Final Environmental Impact Report (Final EIR)

Los Angeles International Airport (LAX) Bradley West Project

Responses to Comments and Corrections and Additions to the Draft EIR

September 2009

Figure 4.2-5b

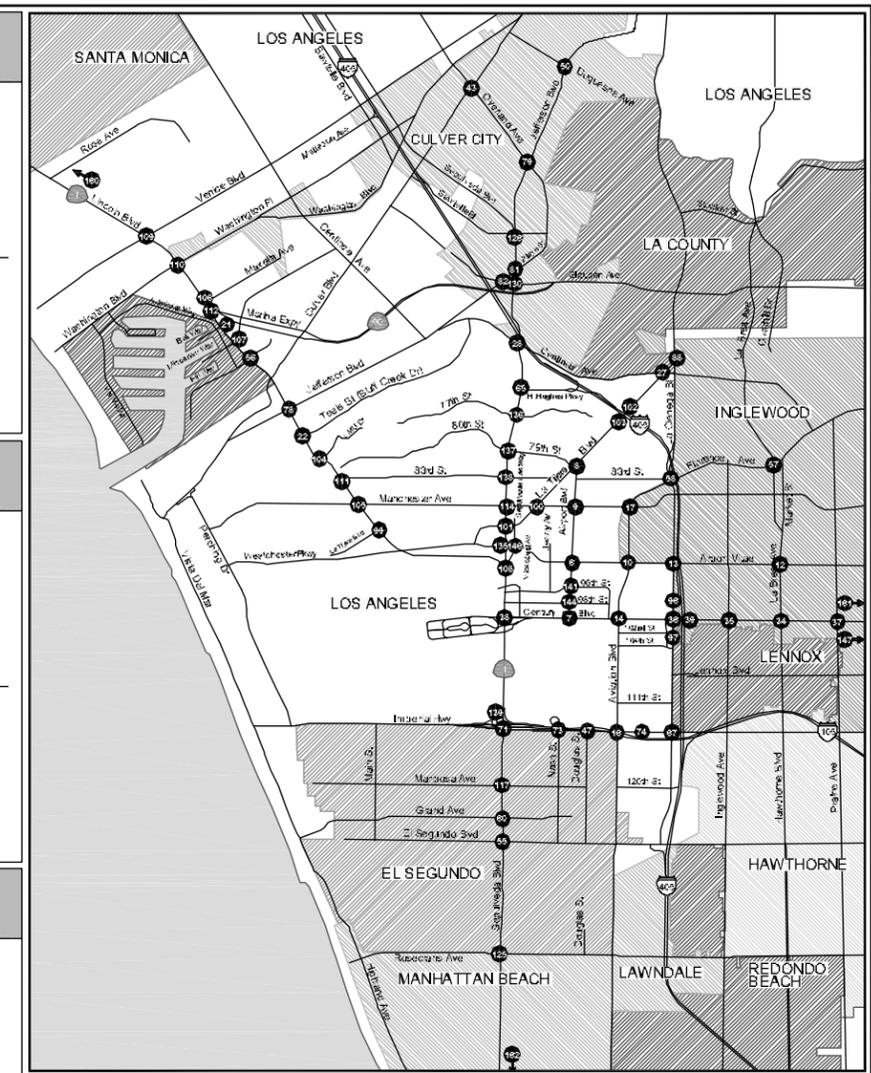
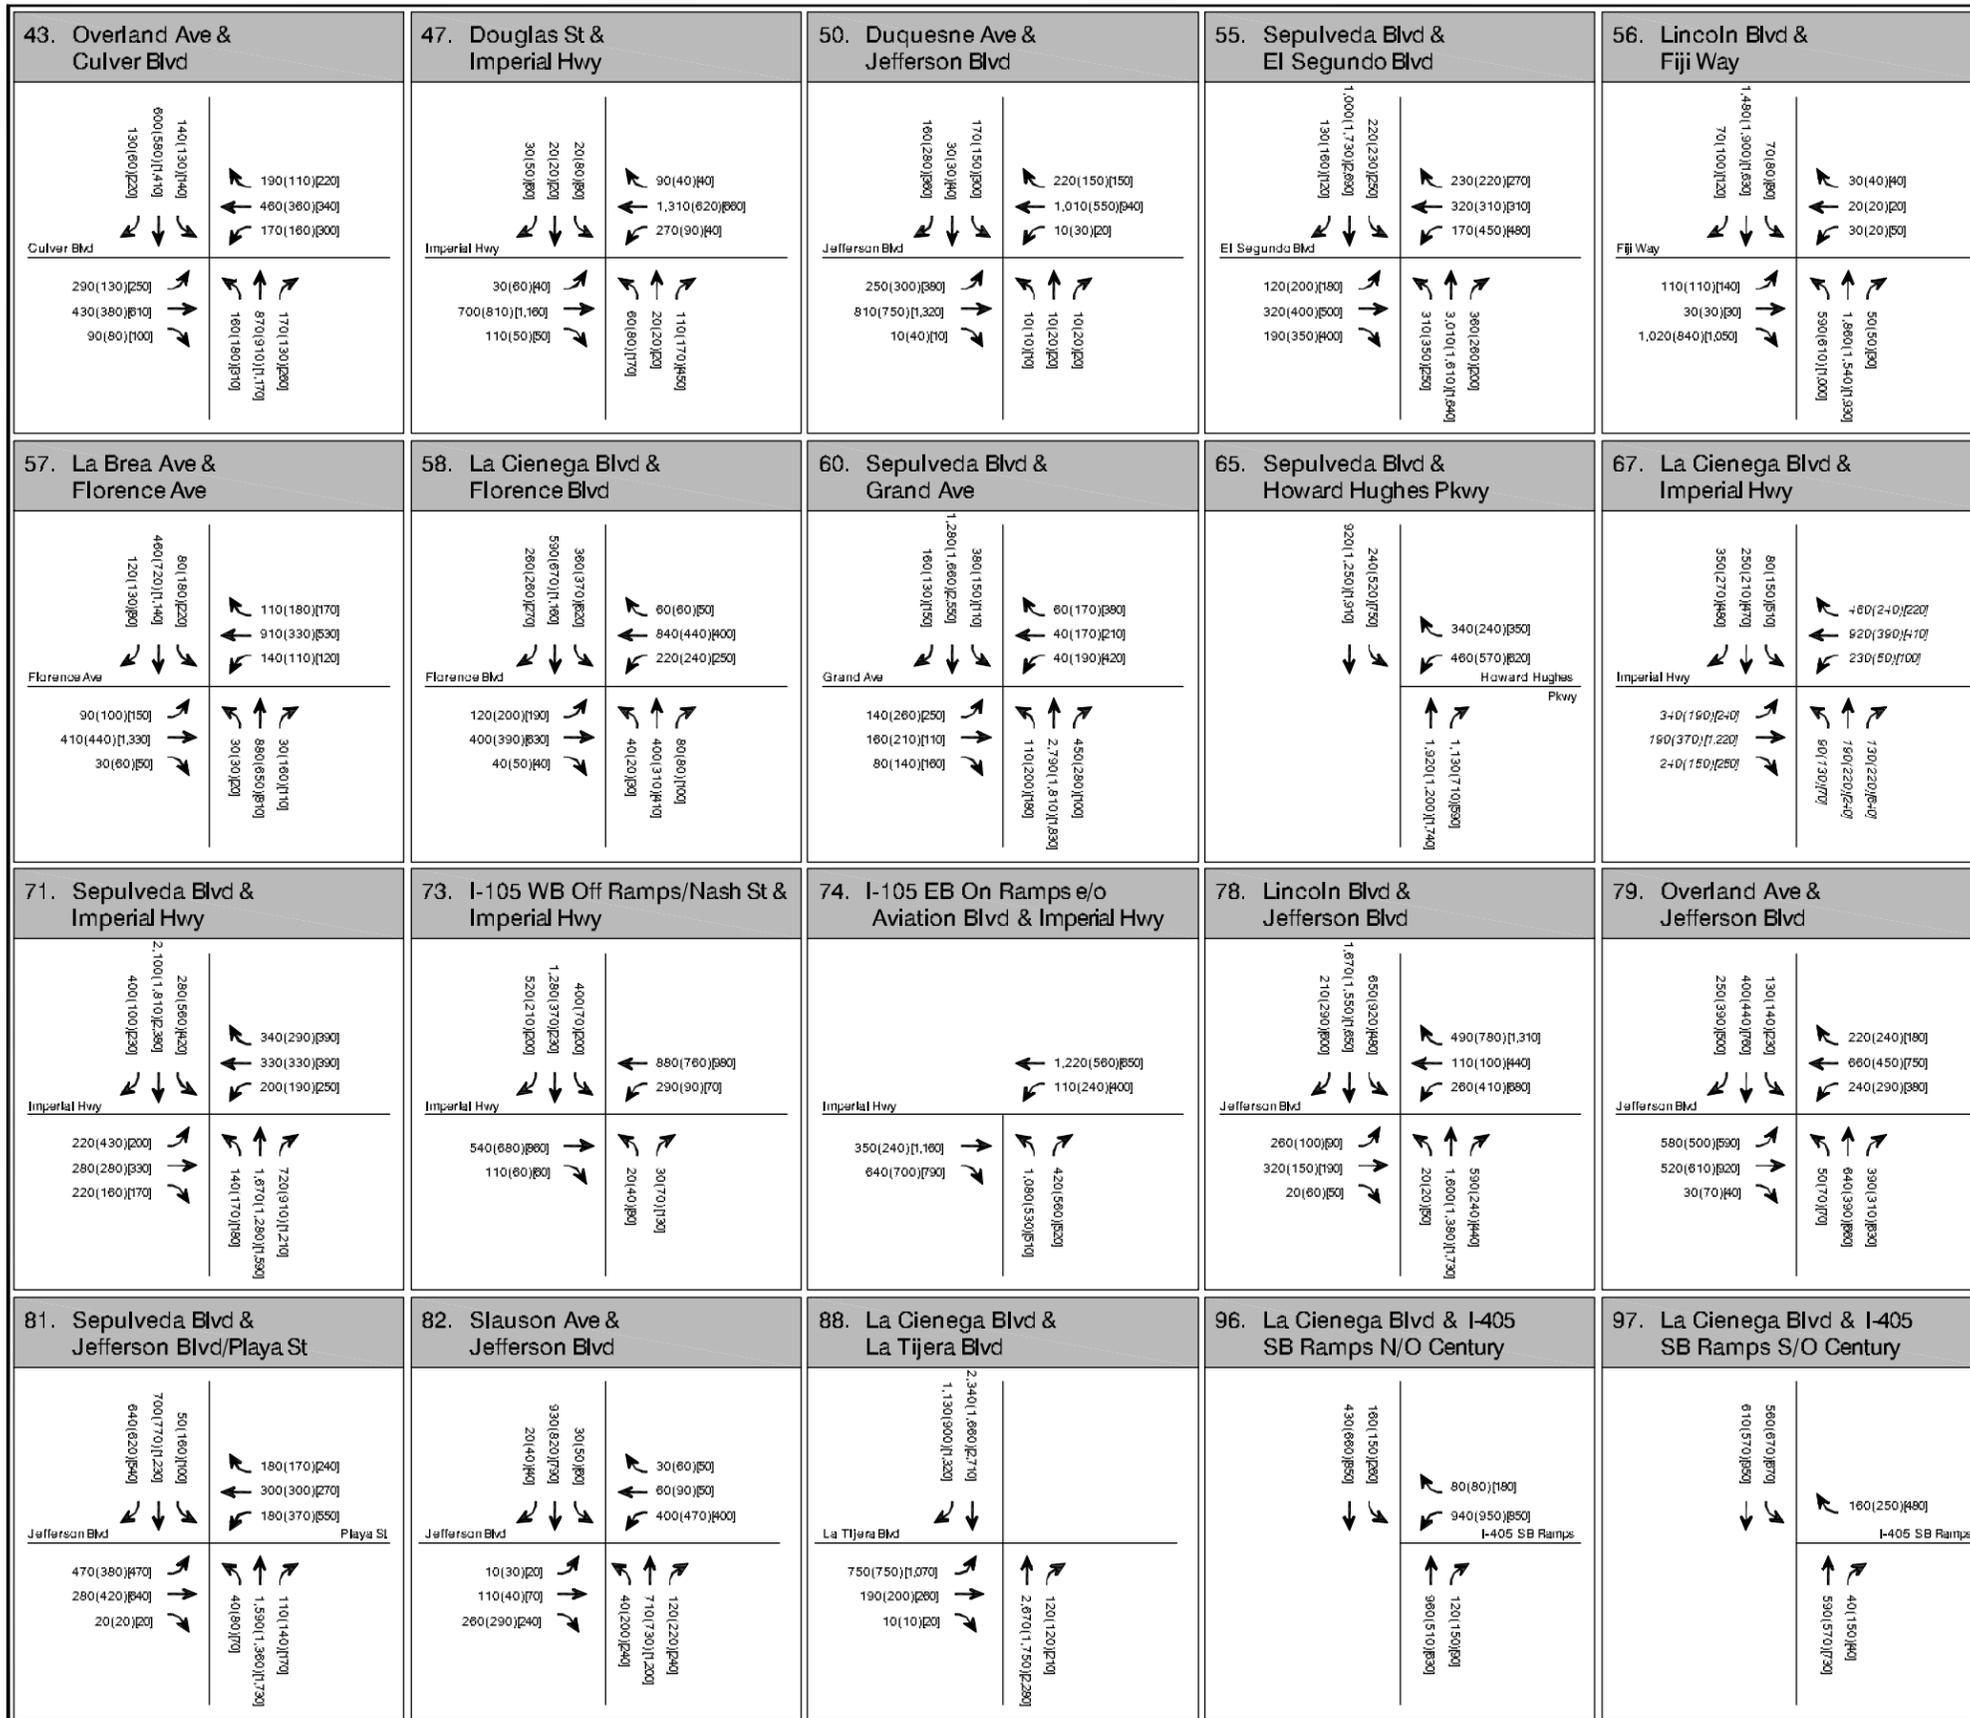
Comment: Volume 4, Appendix C-5, page 4, La Cienega Boulevard and Imperial Highway (Intersection # 67): The AM peak vehicle counts for Existing Conditions do not match those shown in Volume 1 (Main Document), Figure 4.2-3b; similar errors occur with the Mid-day and PM peak vehicle counts. All intersection capacity analysis effected by these errors should be revised accordingly and corresponding mitigation measures and potential improvements should be identified and evaluated for any anticipated significant impacts. If similar errors occur for other project scenarios (e.g. "No Project," "Plus Project" etc.) then capacity analysis calculations and any resulting potential mitigation measures should be also revised accordingly.

Response: The typographical error is noted. In response, Figure 4.2-3b on page 4-105, Figure 4.2-4b on page 4-139, and Figure 4.2-5b on page 4-147 of the Bradley West Project Draft EIR have been revised. Please see Chapter 3, Corrections and Additions to the Bradley West Project Draft EIR. The intersection capacity analyses under all scenarios are not affected by this typographical error as it only occurred in the figures. The correct values were used in the LOS calculations and hence no revisions to the LOS calculations are required.

Figure 4.2-5c

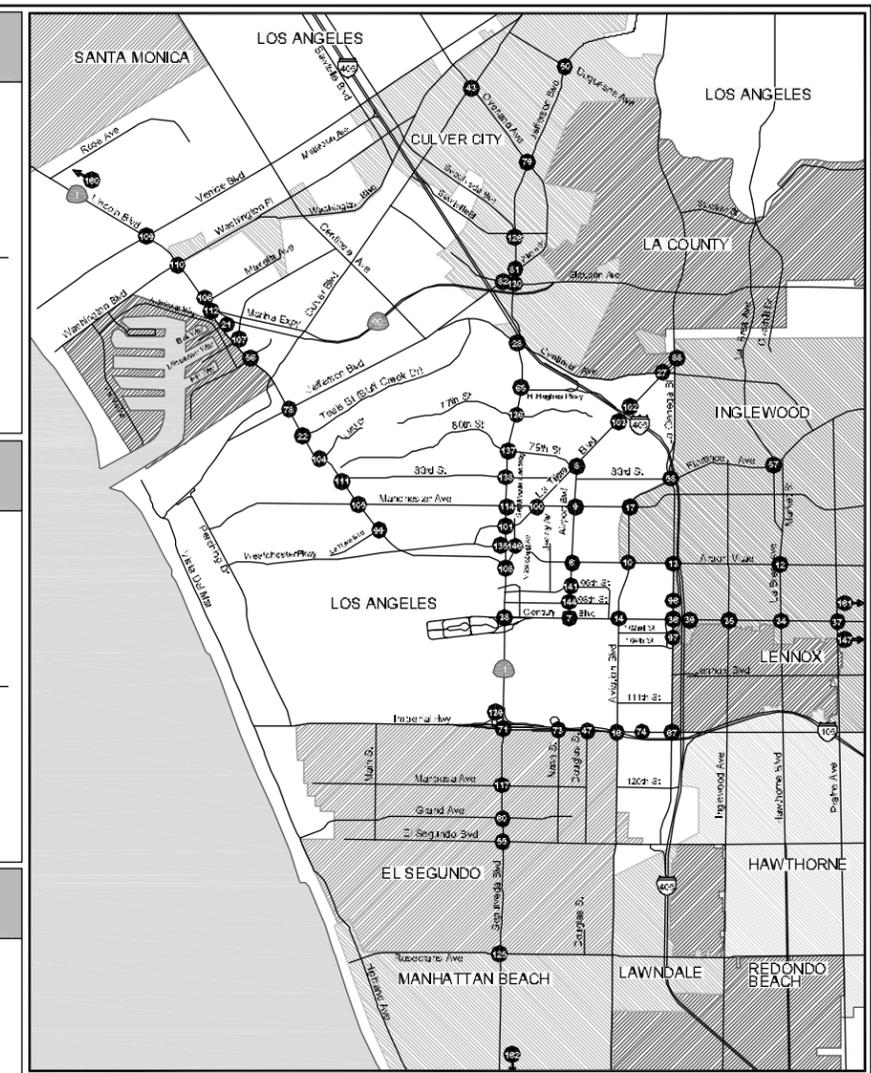
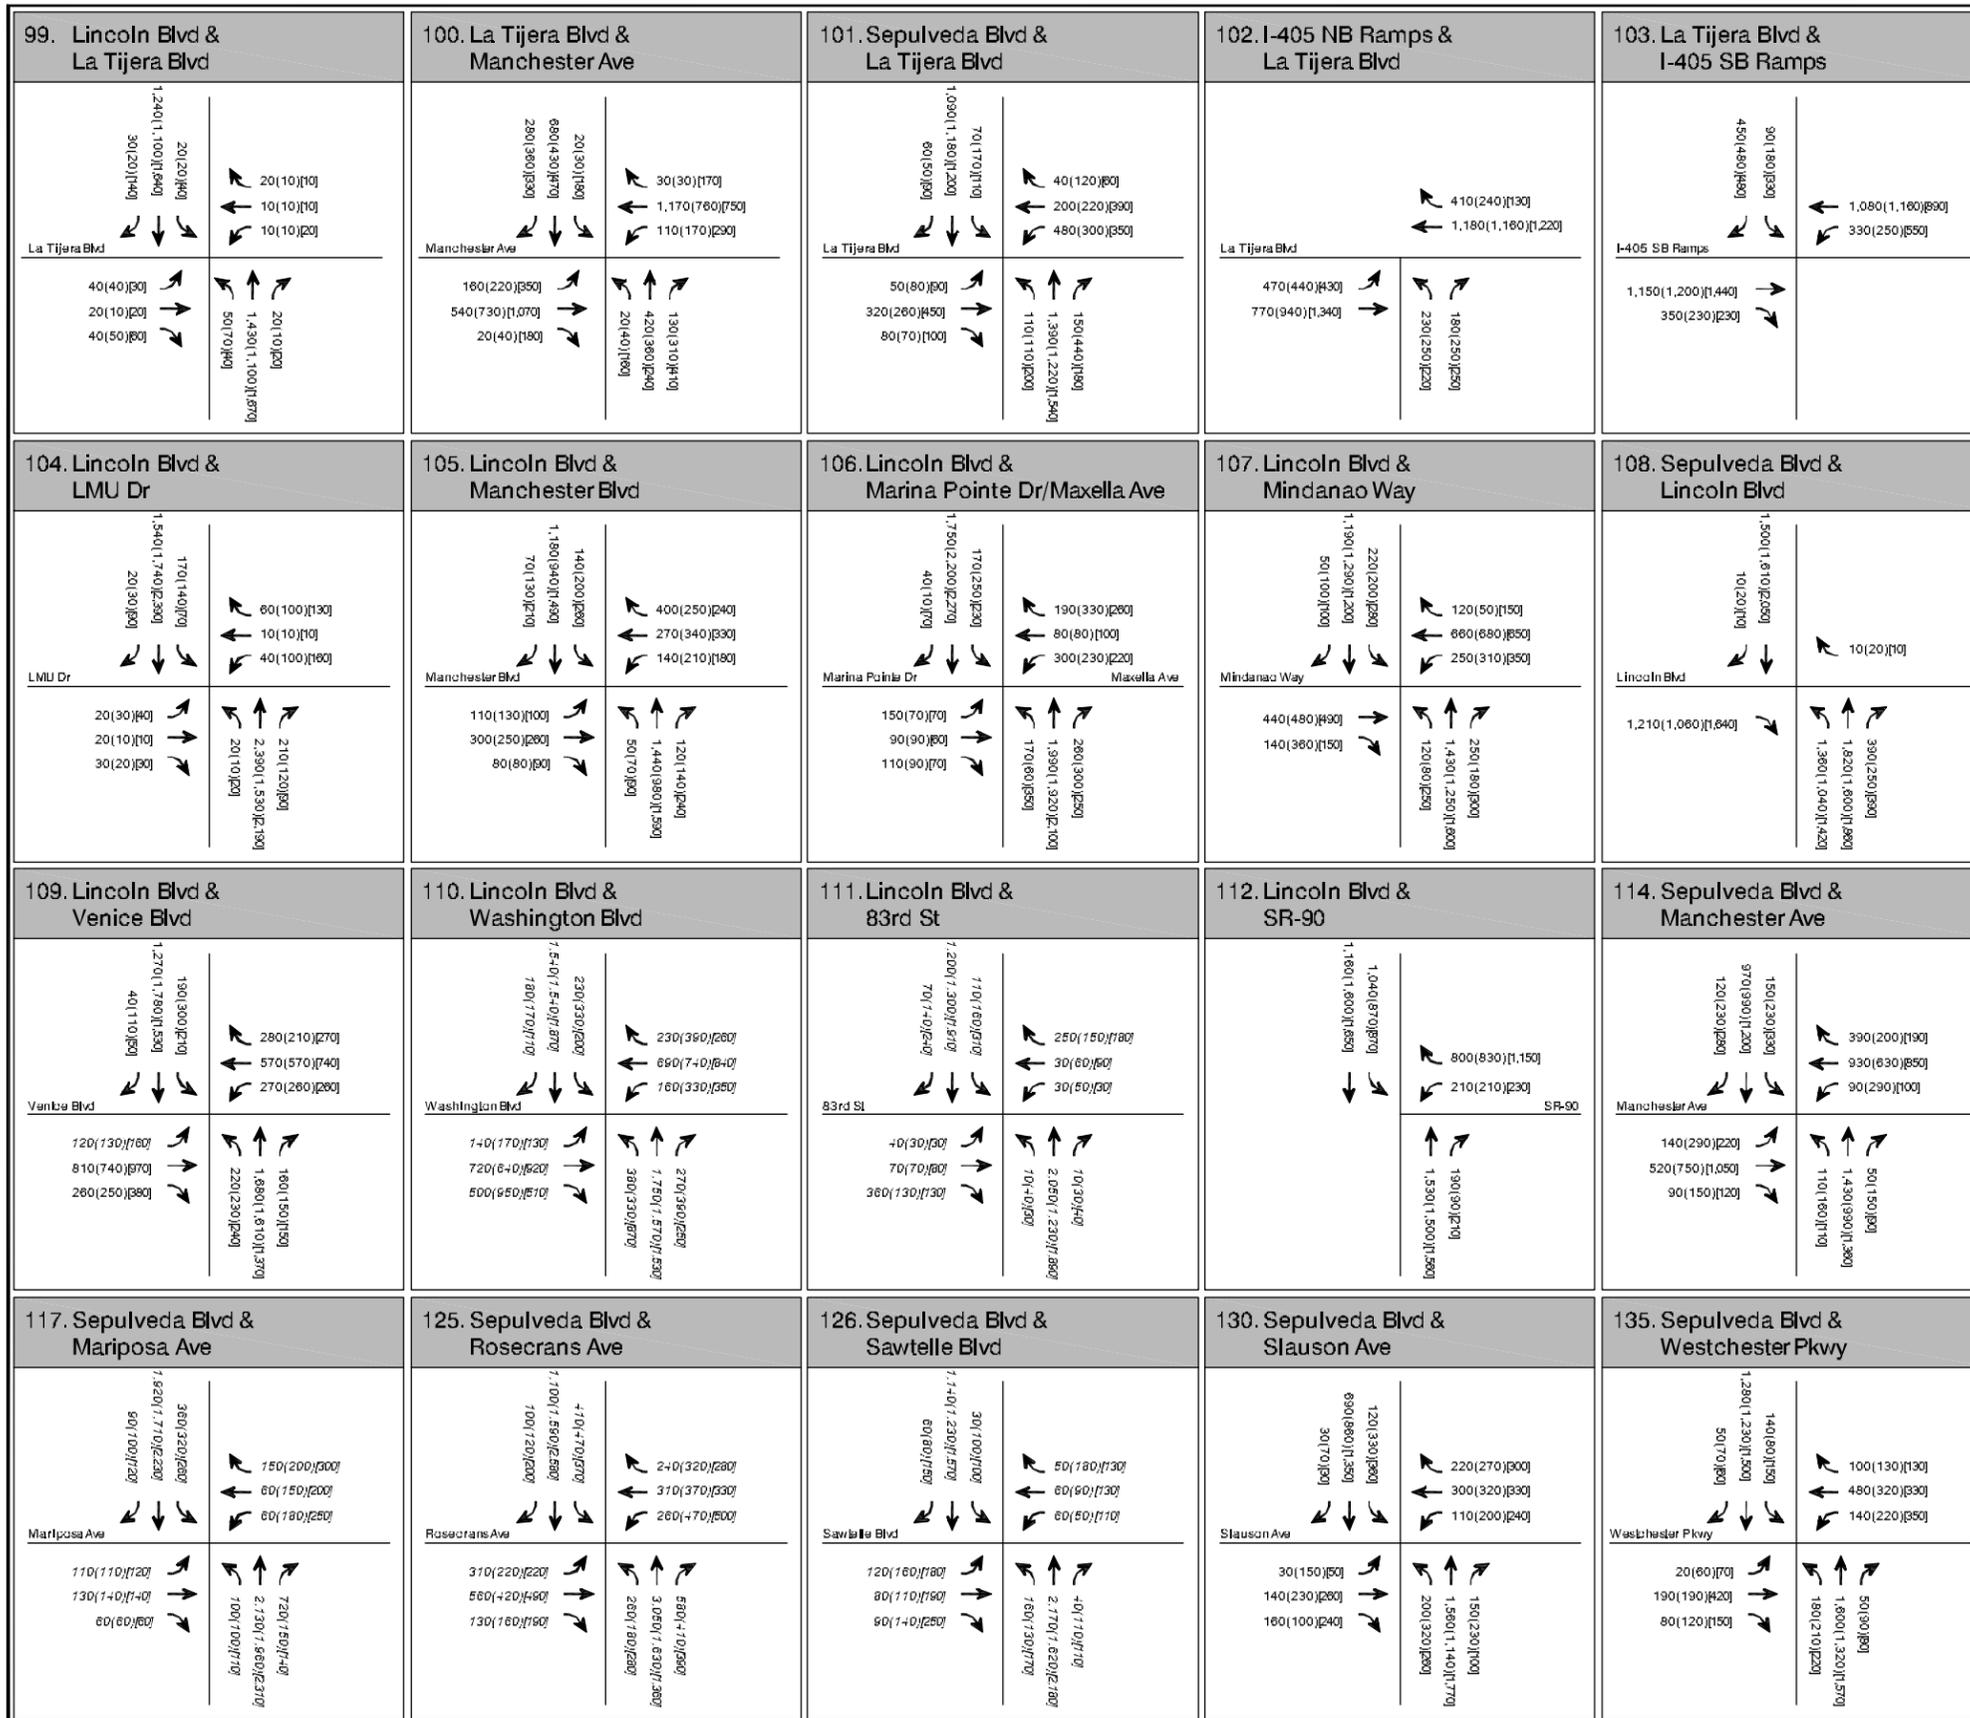
Comment: Volume 4, Appendix C-5, page 9, Lincoln Boulevard and Washington Boulevard (Intersection # 110): The AM peak vehicle counts for Existing Conditions do not match those shown in Volume 1, Figure 4.2-3c; similar errors occur with the Mid-day and PM peak vehicle counts. All intersection capacity analysis effected by these errors should be revised accordingly and corresponding mitigation measures and potential improvements should be identified and evaluated for any anticipated significant impacts. If similar errors occur for other project scenarios (e.g. "No Project," "Plus Project" etc.) then capacity analysis calculations and any resulting potential mitigation measures should also be revised accordingly.

Comment: Volume 4, Appendix C-5, page 9, Lincoln Boulevard and 83rd Street (Intersection #111): The AM peak vehicle counts for Existing Conditions do not match those shown in Volume 1, Figure 4.2-3c; similar errors occur with the Mid-day and PM peak vehicle counts. All intersection capacity analysis effected by these errors should be revised accordingly and corresponding mitigation measures and potential improvements should be identified and evaluated for any anticipated significant impacts. If similar errors occur for other project scenarios (e.g. "No Project," "Plus Project" etc.) then capacity analysis calculations and any resulting potential mitigation measures should also be revised accordingly.

Response: The typographical error is noted. In response, the volume figure for the Lincoln Boulevard and Washington Boulevard intersection in Figure 4.2-3c on page 4-107, Figure 4.2-4c on page 4-141, and Figure 4.2-5c on page 4-149 of the Bradley West Project Draft EIR has been revised. Please see Chapter 3, Corrections and Additions to the Bradley West Project Draft EIR. However, the revised Mid-day southbound through volume at the Lincoln Boulevard and Washington Boulevard intersection does not match the vehicle counts because the volume was adjusted to be consistent with the traffic volumes at nearby intersections. As stated on page 4-90 in Section 4.2 of the Bradley West Project Draft EIR, traffic volumes, counted or forecasted, are balanced to ensure a reasonable amount of vehicles are either gained or lost between adjacent intersections. The volumes used in the intersection analysis for all scenarios match the revised volumes for all periods; therefore, the intersection analysis is not affected and no additional revisions are required.

Response: The typographical error is noted. In response, the volume figure for the Lincoln Boulevard and 83rd Street intersection in Figure 4.2-3c on page 4-107, Figure 4.2-4c on page 4-141, and Figure 4.2-5c on page 4-149 of the Bradley West Project Draft EIR has been revised. Please see Chapter 3, Corrections and Additions to the Bradley West Project Draft EIR. However, the revised AM and Mid-day northbound and southbound through volumes at the Lincoln Boulevard and 83rd Street intersection do not match the vehicle counts because the volume was adjusted to be consistent with the traffic volumes at nearby intersections. As stated on page 4-90 in Section 4.2 of the Bradley West Project Draft EIR, traffic volumes, counted or forecasted, are balanced to ensure a reasonable amount of vehicles are either gained or lost between adjacent intersections. The volumes used in the intersection analysis for all scenarios match the revised volumes for all periods; therefore, the intersection analysis is not affected and no additional revisions are required.
